# TECHNICAL SERVICE BULLETIN

No.LTB00477/2012

**Subject/Concern:** Clutch Noise

Defender (LD)	Year: 2007-2012 VIN Range: 7A732615-CA421360
---------------	---

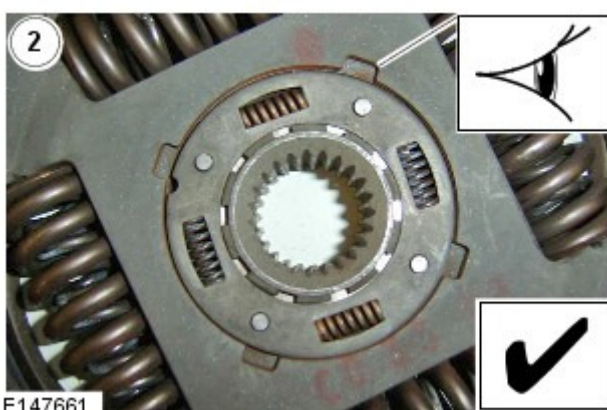
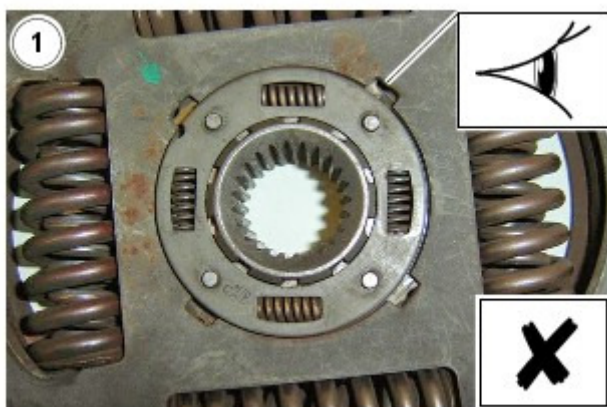
**Cause:** The thrust washer fitted around the centre hub of the clutch disc may have sheared (this does not cause operation failure of the clutch it generates an audible noise only). **Suggested Customer Concern Code - P24.**

**An improved clutch kit with a bonded washer has been introduced as an assembly.**

**Initially the new part number will be LR029894. LR029894 will supersede to LR037956 in the near future to align with the production part number. Please note there is no difference in the clutch kit contained in LR029894 and LR037956.**

Parts Required		
Description	Part Number	Quantity
Clutch kit	LR029894	1

E147661

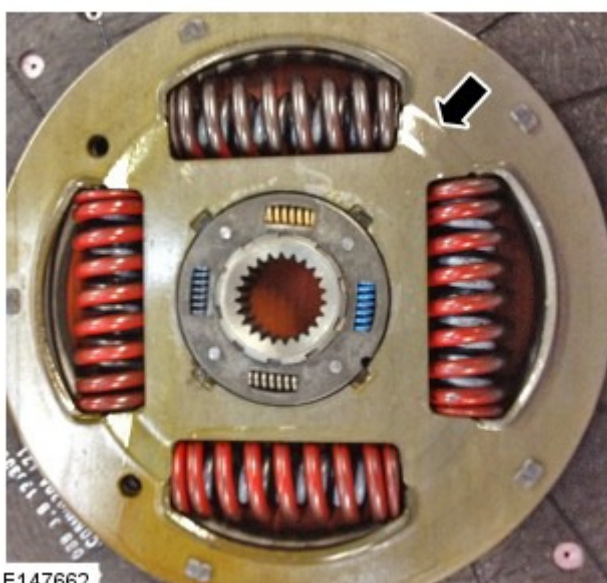
1. Remove the clutch disc and pressure plate (see TOPIx Workshop Manual, section 308-01).
2. Inspect the clutch disc for signs of damage to the thrust washer.
  1. Damaged or missing thrust washer.
  2. Correctly located thrust washer.

3. **The new design clutch disc has a gloss finish and a bonded thrust washer.**

Install the new design clutch disc and pressure plate (see TOPIx Workshop Manual, section 308-01).
